# DISCIPLINARY COMMITTEE DECISION COMPLAINT ABOUT KEVIN O'CONNOR

**18 June 2021**

Representative calculations for the wall panel/foundation "TCM"  
connection

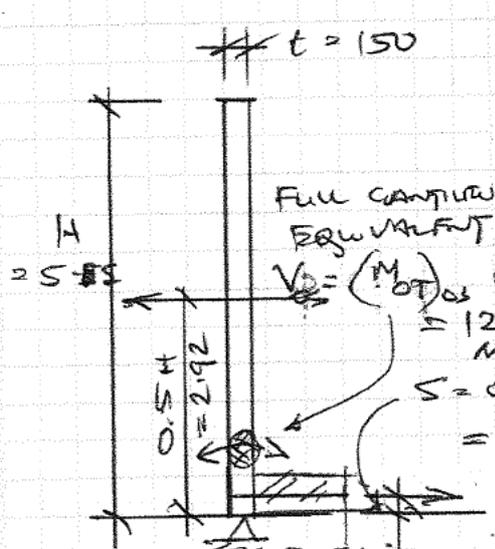
- C5.6.4 As part of my review, I have prepared some preliminary design calculations for the TCM inserts intended to reinforce the wall panel/foundation junction for the resistance of both out-of-plane face/bending loads and in-plane (shear) loads in a typical panel within this building.

SECTION 1/ S1

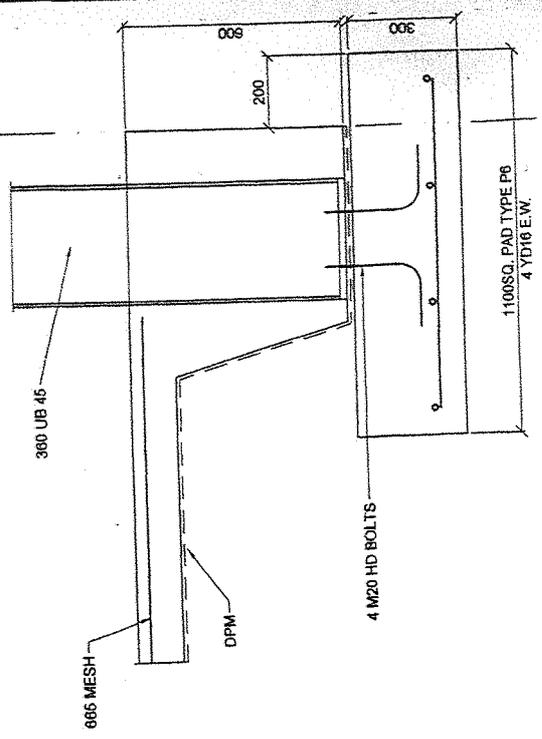
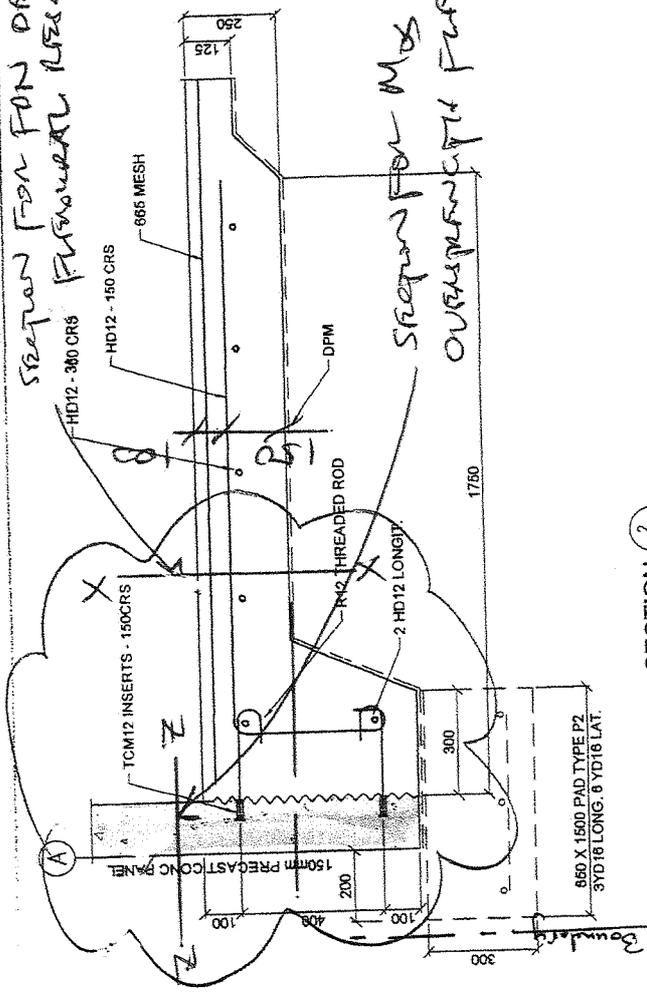
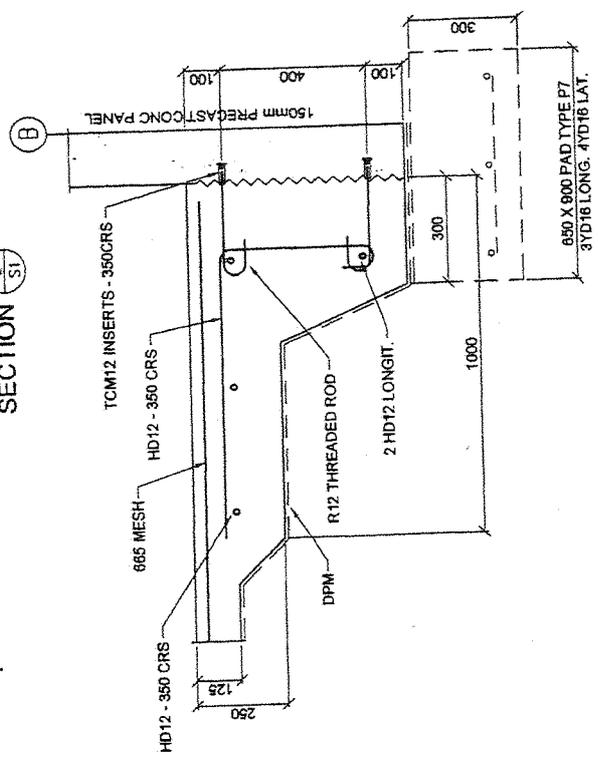
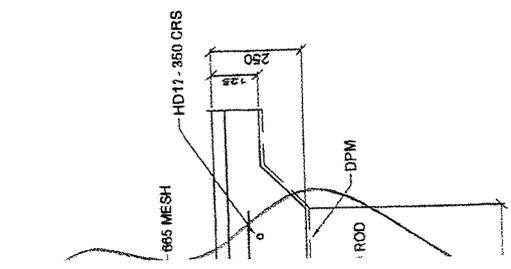
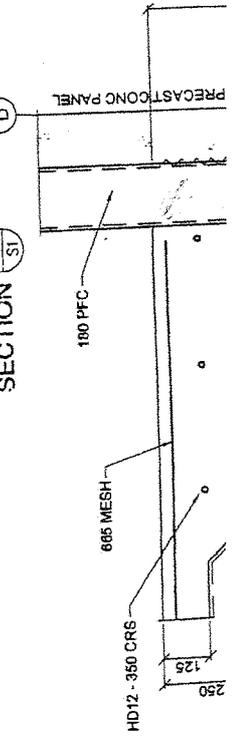
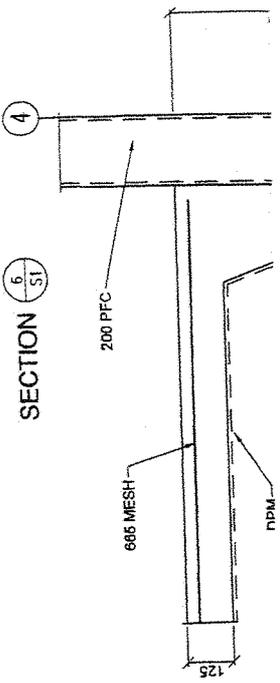
C5.6.2 In my opinion, the designer has assumed that the overturning moment in the slab can be resisted by a force couple comprising the cast-in insert and a reaction point at the base of the panel some 300 mm below (refer KOA calculations at pages C3 (sketch), C6 ( $h_t = 300$  mm), and C7 (M insert)). This assumption would be valid if the edge thickening of the slab was 400 mm deep (reference Section 1/S01 on drawing S12) for the full length of the wall panel, but does not, in this case, because

this detail only occurs at the pile support. In reality, the base of the panel is unrestrained as per Section 6/S01 on drawings S13 and the 300 mm lever arm cannot apply.

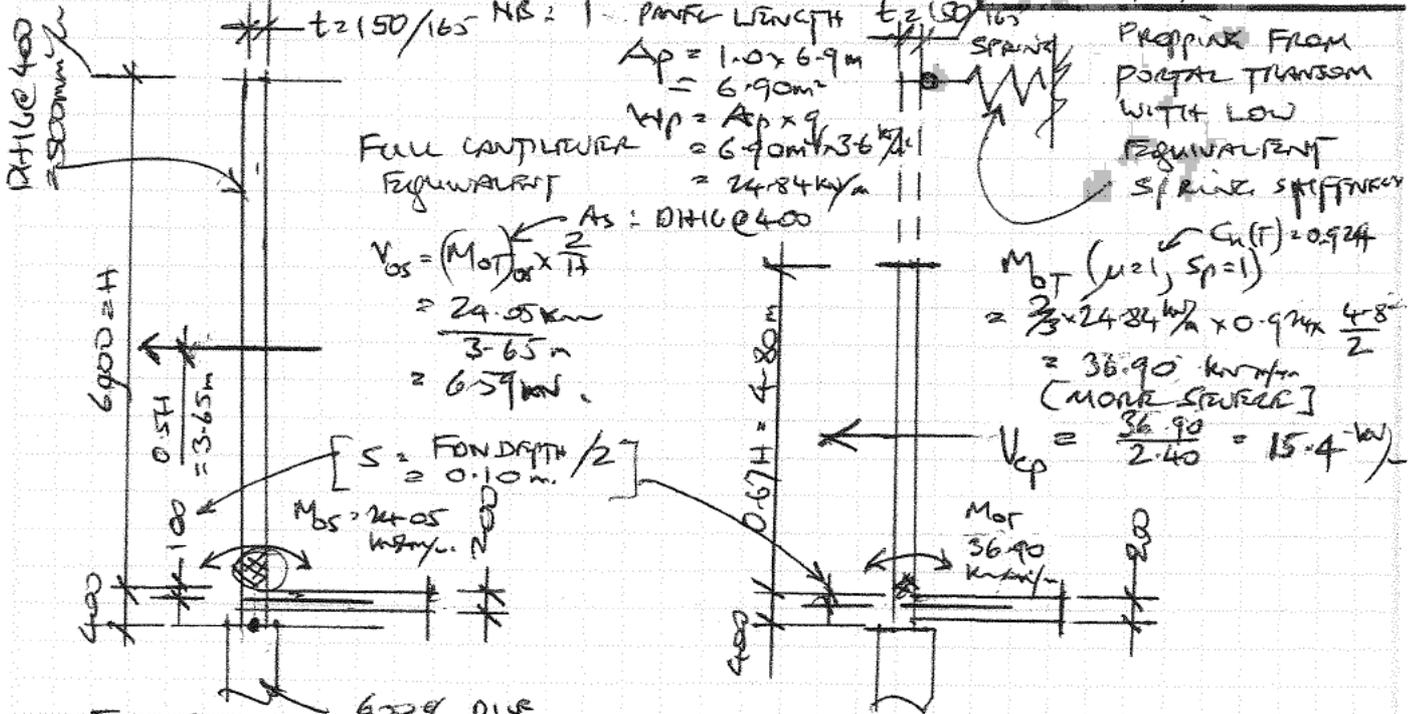
As part of my review, I have prepared some preliminary design calculations for the TCM inserts intended to reinforce the wall panel/foundation junction for the resistance of both out-of-plane face/bending loads and in-plane (shear) loads in a typical panel within this building.

These calculations suggest that these TCM connections in this particular building are significantly under-designed - ie say 20% of a fully compliant requirement - for the critical severe seismic (ULS) design case required by the relevant loading standard - refer Appendix C5 calculations ref 49158/4/01-05.
